**Re: Gordon Property – 257 East Middle Patent Road  
Tax ID: 88.04-1-13, R-4A Zone, 114.5 Acres  
Proposed Driveway Curb Cut Modifications  
Revised & New Information**

*The following information is provided in response to the Town Planner's (TP) Staff Report Memo, dated May 24, 2021, General Comments on page 2 of 2.*

*The following information responds to comments noted in the TE's Review Memorandum for the project, dated May 20, 2021. The following responses to the "General Comments" 1-15 are provided below.*

## GORDON PROPERTY PROPOSED DRIVEWAY REALIGNMENT

## TOWER LADDER TRUCK TURNING RADIUS

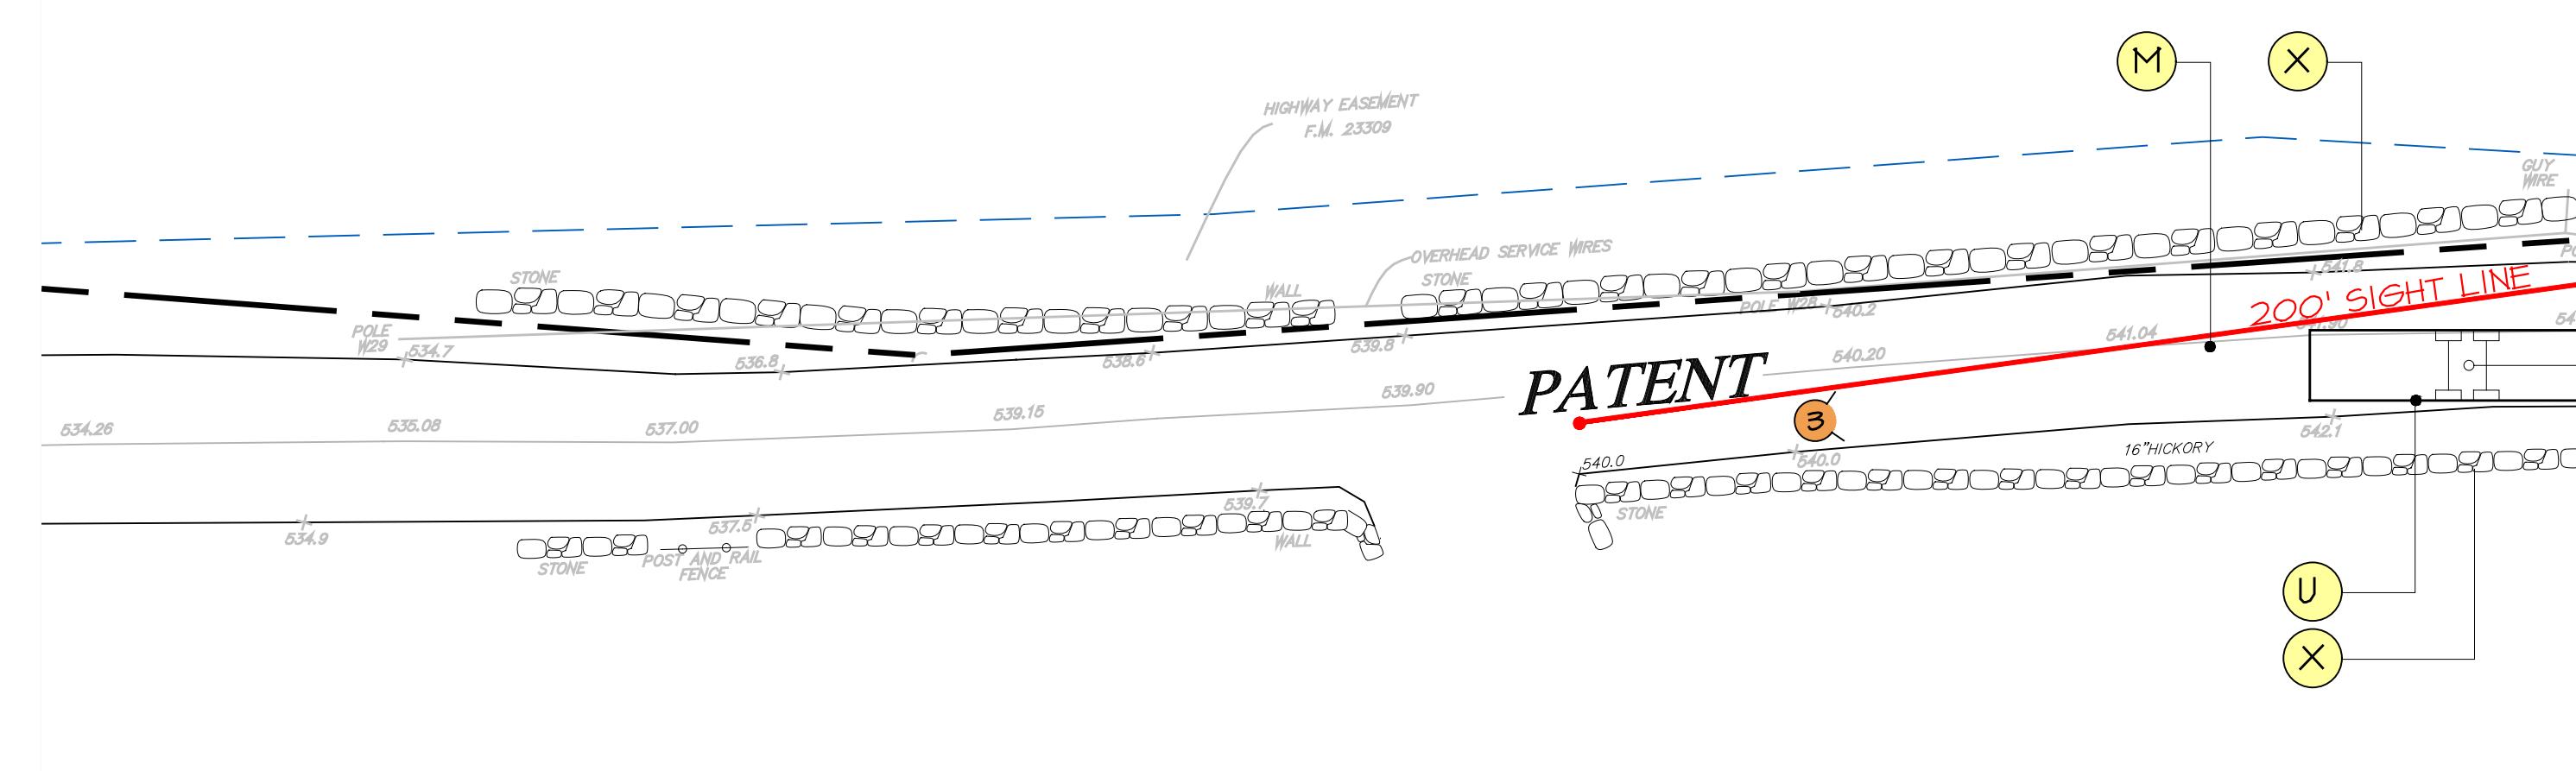
7. GC #7 – Re: Maximum Width of Curb Cut at 18' Wide. The driveway entries have been revised to show a maximum 18' curb cut width at the intersection of East Middle Patent Road. At subject Area 1 we note that the emergency vehicle turning radius needed to enter the property is much wider than 18'. In order to provide a stable and supported entry for the emergency vehicles we have proposed "stabilized grass" flanking both sides of the driveway at Subject Area 1. The stabilized grass is shown as a green hatch pattern labeled as stabilized grass. A detail of the stabilized grass is shown on Sheet 4 of 6. It is also noted that stone curbing between the driveway and stabilized grass shall be installed at 2" height. Stone curing at other site areas is 4"-5" height. The lower 2" height stone curbing will allow a vehicle to easily track over the 2" height curbing. An angled transition stone curb shall serve to transition between the 2" height stone curb and the higher 4"-5" height stone curb where the stabilized grass ends.

## DRIVEWAY PROFILE - SOUTH ENTRY

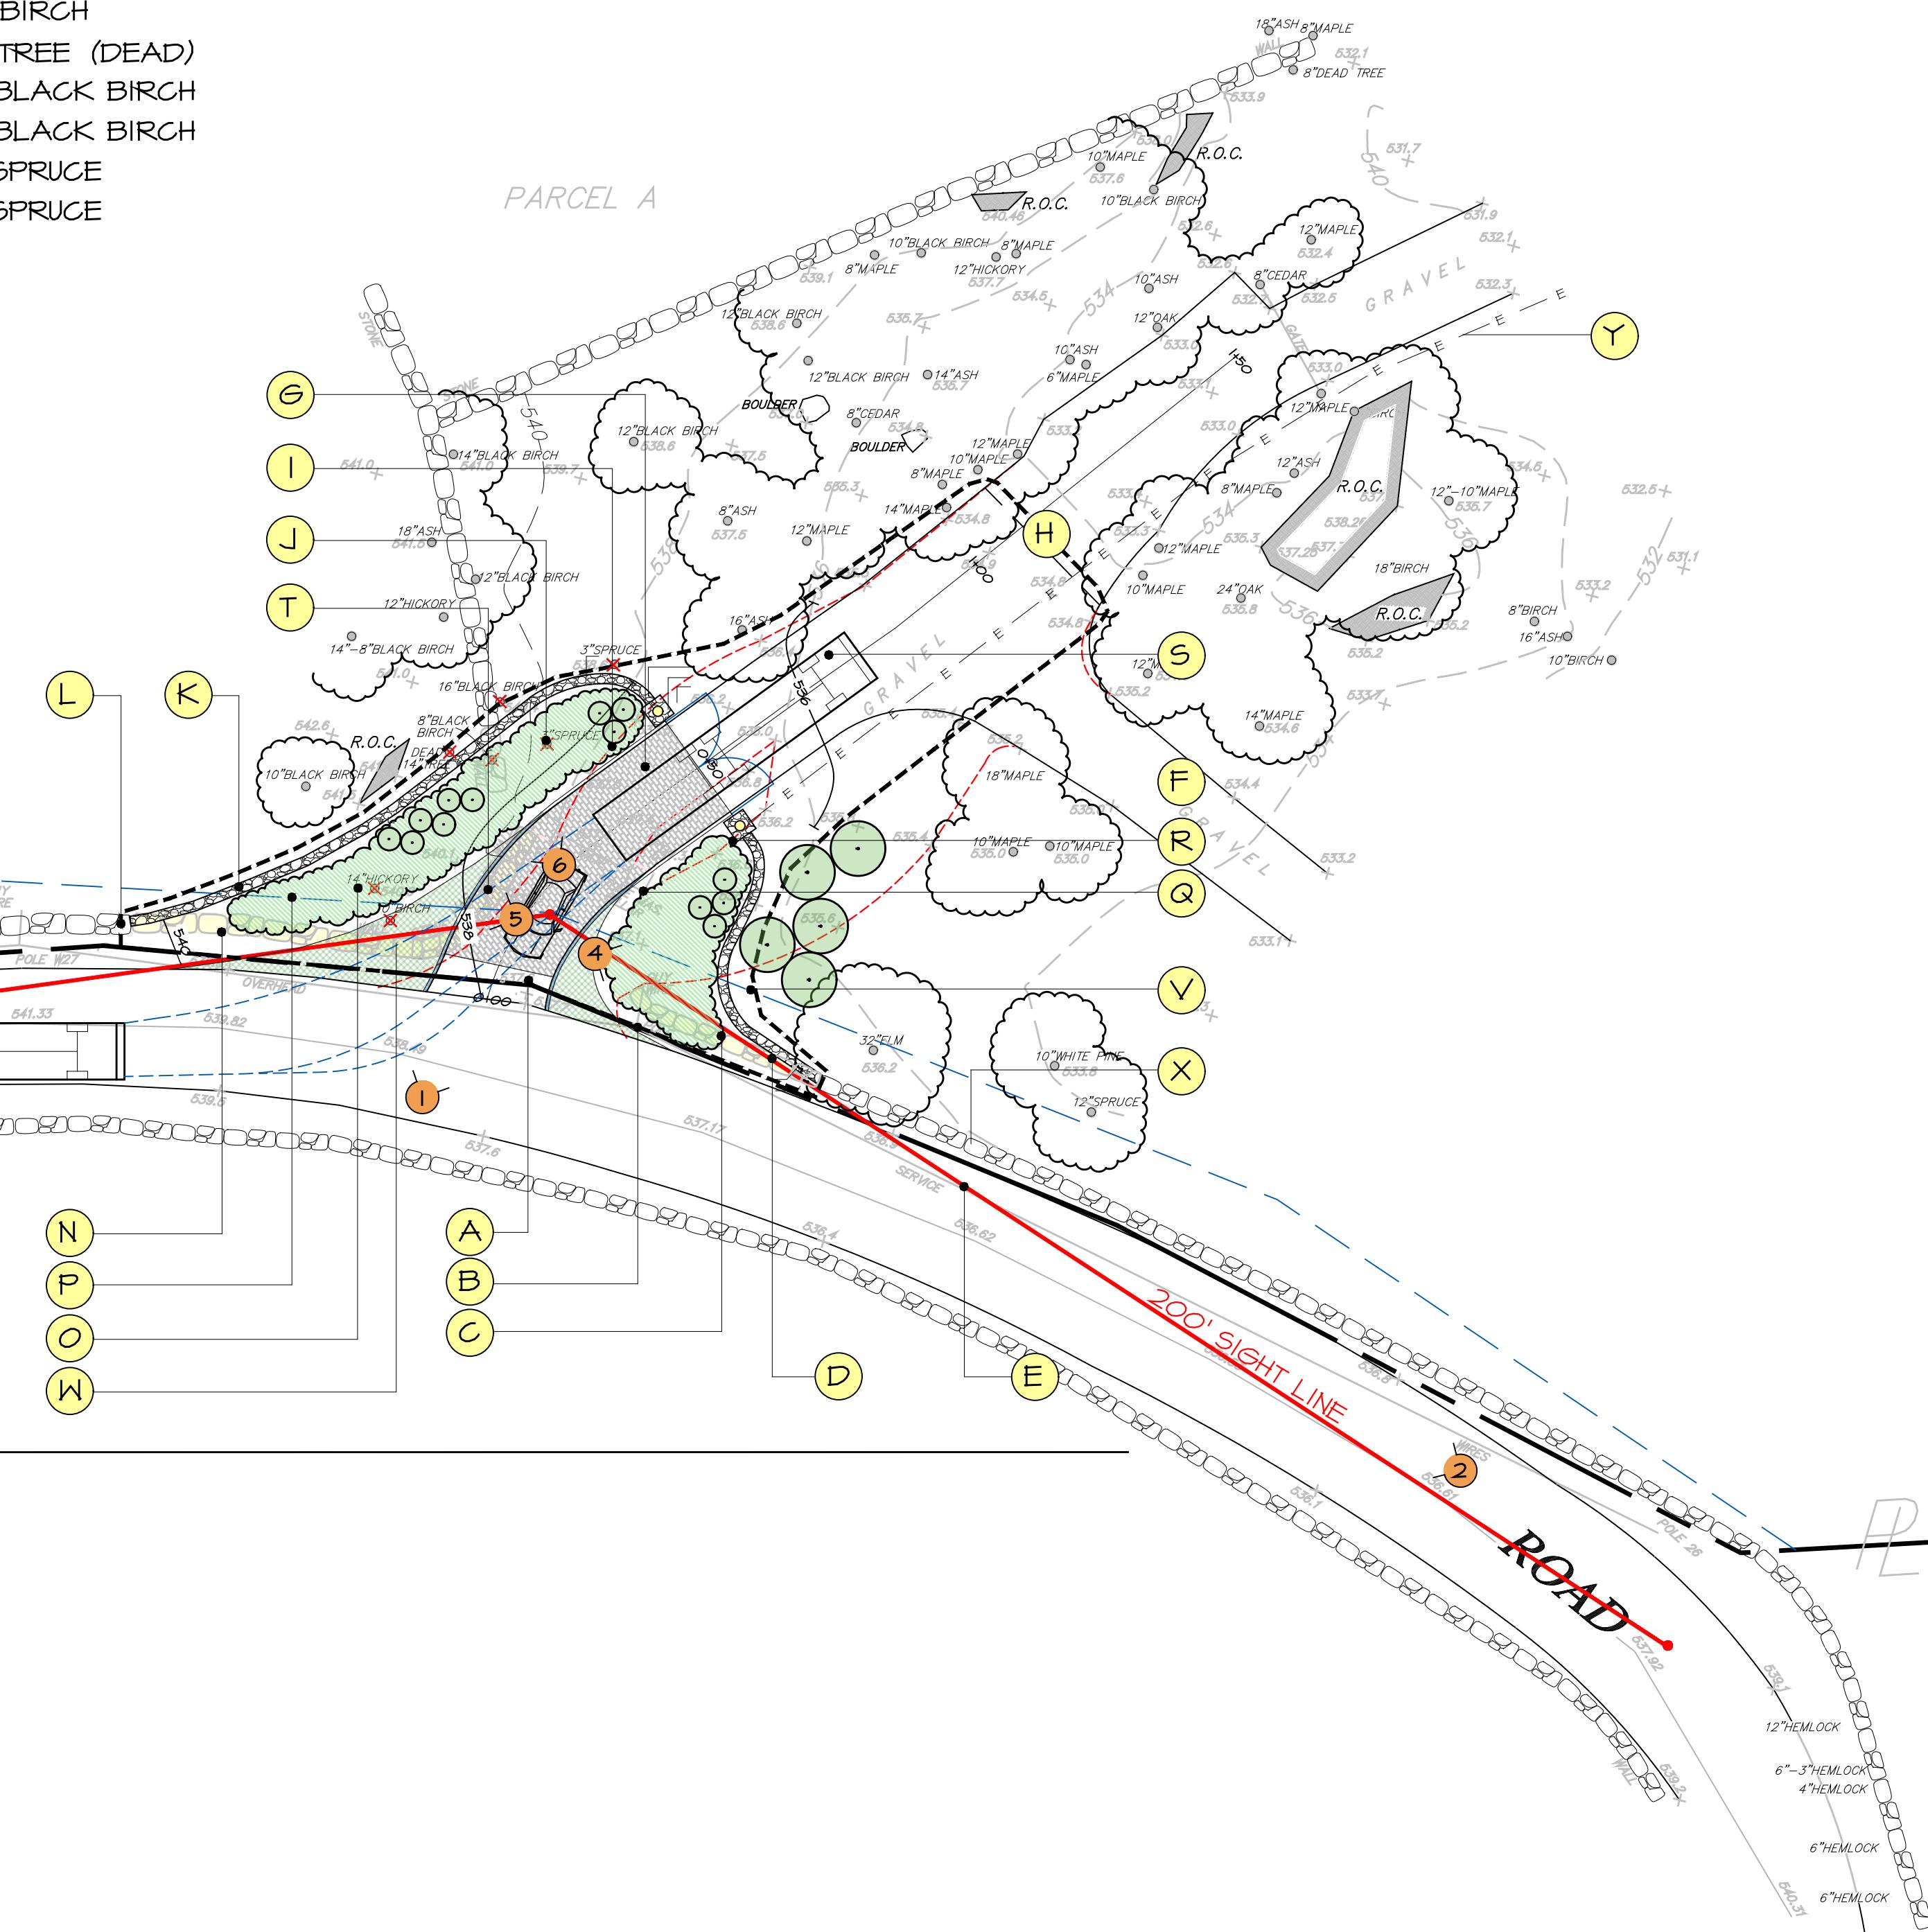
5. GC #5 – Re: Driveway Profile. A driveway profile is now provided on the plans for Subject Area 1. We note that no change to the existing gradient (2%-3%) is proposed. A 2% entry platform at both driveway entries has been provided.

## SIGHTLINE PROFILE - SUBJECT AREA

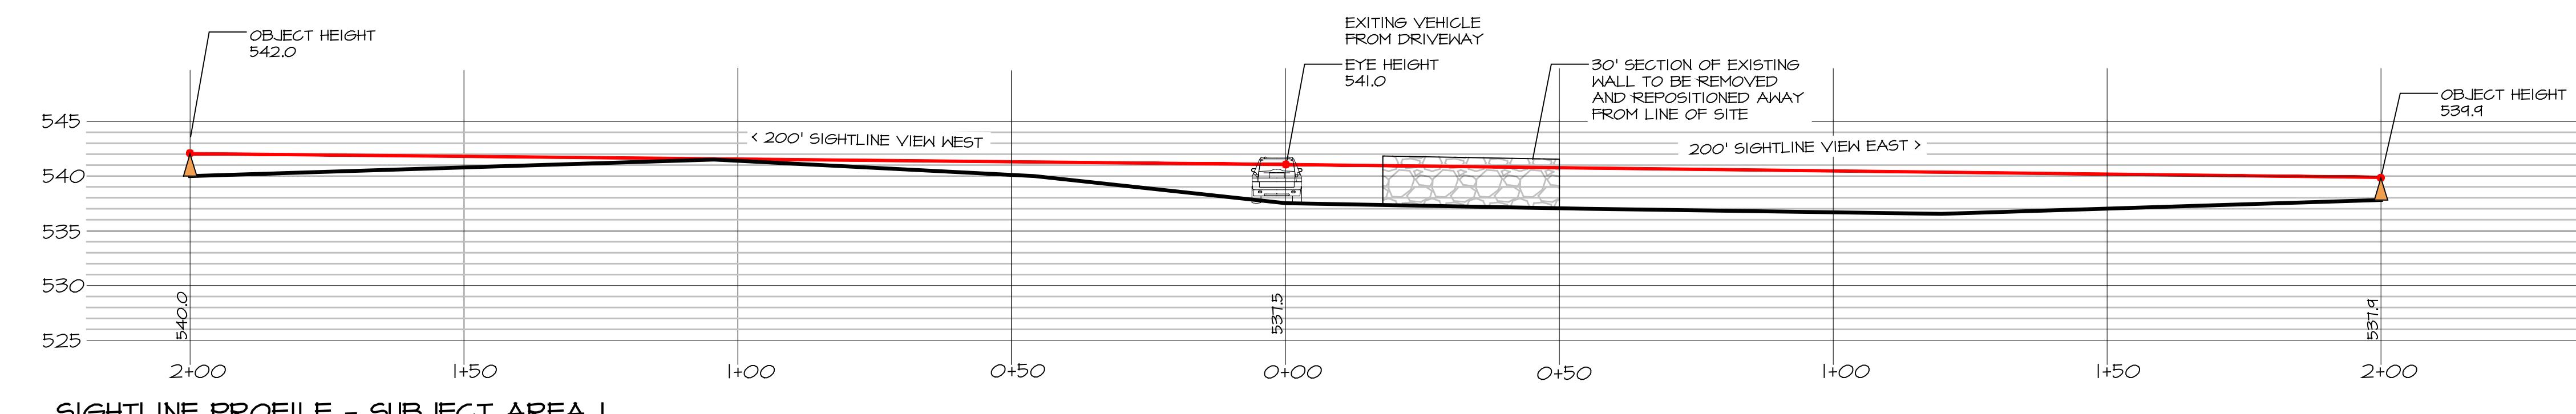
6. GC #6 – Re: Sight Line Profiles. The sight line profiles at both Subject Area 1 and Subject Area 2 have been updated to position the driver's eyes on the driveways at a distance of 14' from the road edge and 3.5' above the existing driveway. The sight lines are extended north and south from the driveways along East Middle Patent Road for a distance of 200'. In order to provide clear sighting distance, it was necessary to relocate portions of existing stonewalls flanking the north sides of driveways to allow clear sighting distance. See plans and profiles.

#### DETAILED SITE PLAN

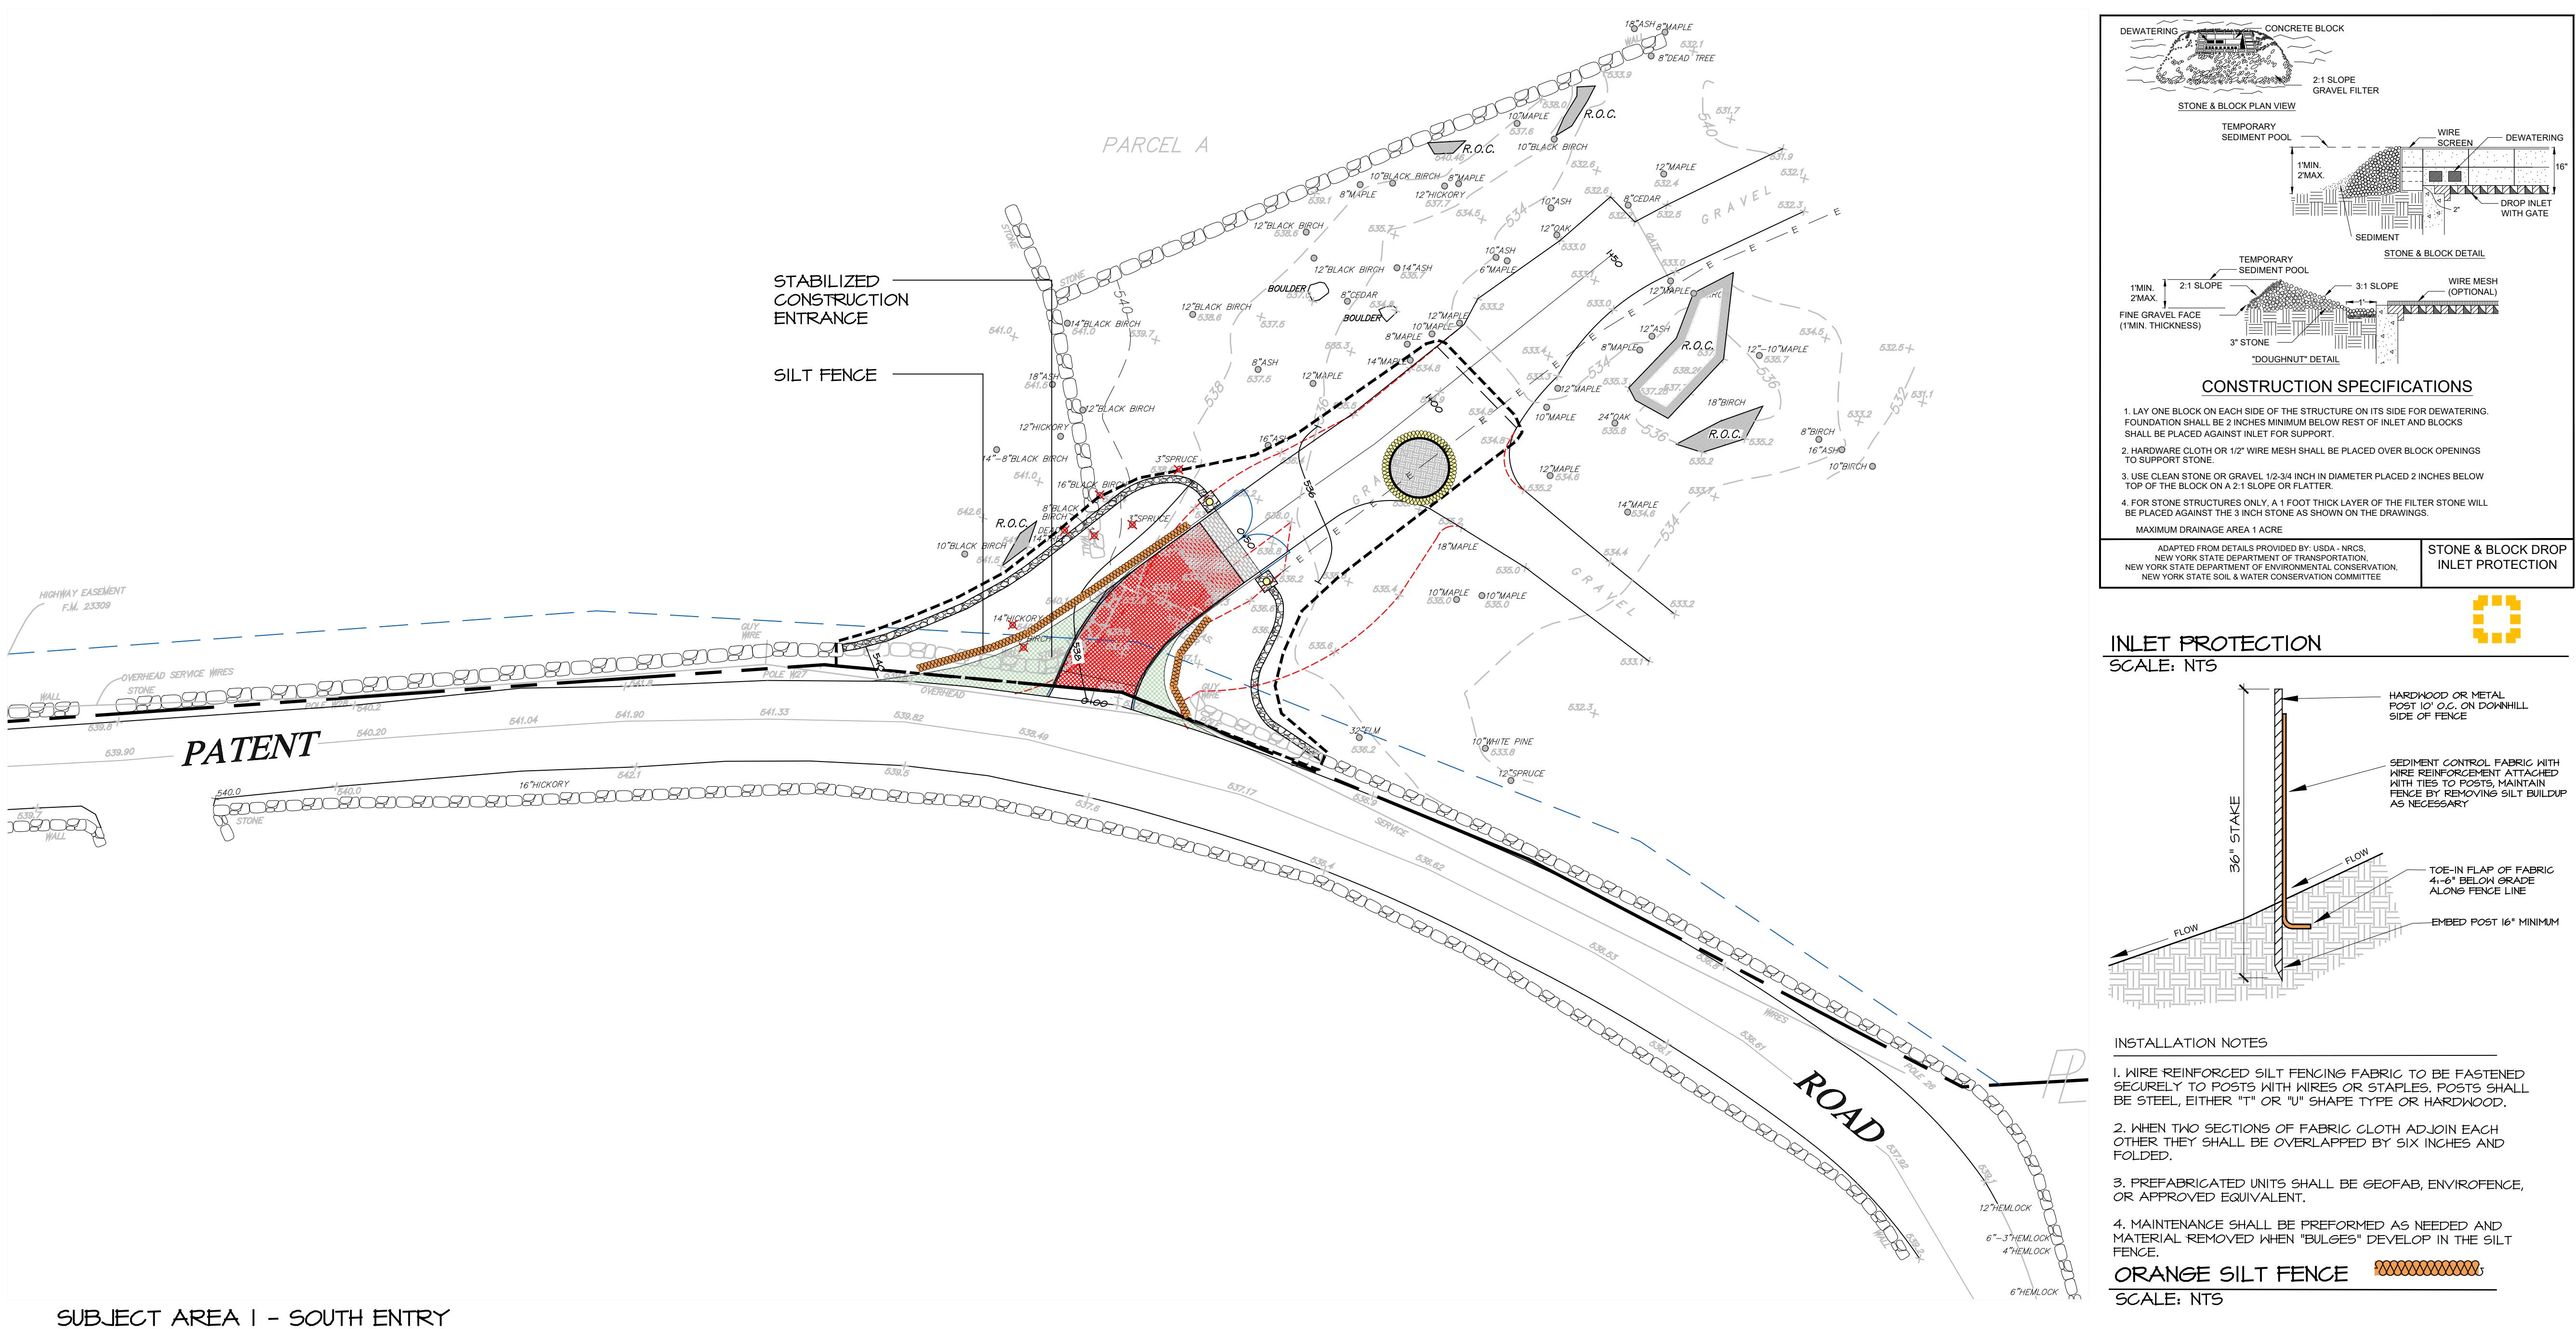
6. Comment #G.5 – Re: Detail for the Proposed Pillars. A detail of the driveway pillars and walls is shown on Detailed Site Plan, Sheet 4 of 6. The pillars will generally match the existing pillars on site. They will measure 3.5' x 3.5' x 6' ht. Maximum pillar height is 6'. Maximum light height on top of the pillars will be 8'. Maximum wall height is 4'. Spot elevations on the walls and pillars have been provided on the plan.

9. Comment #G.8 – Re: Driveway Gates. The driveway gates shall be made of natural products (wood) and be solid. They will not exceed 8' in height. An example of a type of solid driveway gate is provided on the Detailed Site Plan, Sheet 4 of 6. The exact gate style has yet to be decided by the applicant.
